Product / Process Change Notification (PCN)

PCN #: PCN_WL-SBTW_20190617

Affected Series: WL-SBTW; 150141YV73100, 150141YV73110

150141YV73110

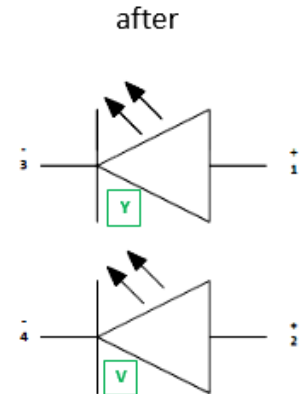
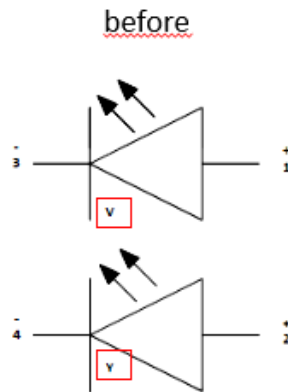
Because of a database mismatch, Würth Elektronik corrected the drawing of schematic. The component itself didn't change.
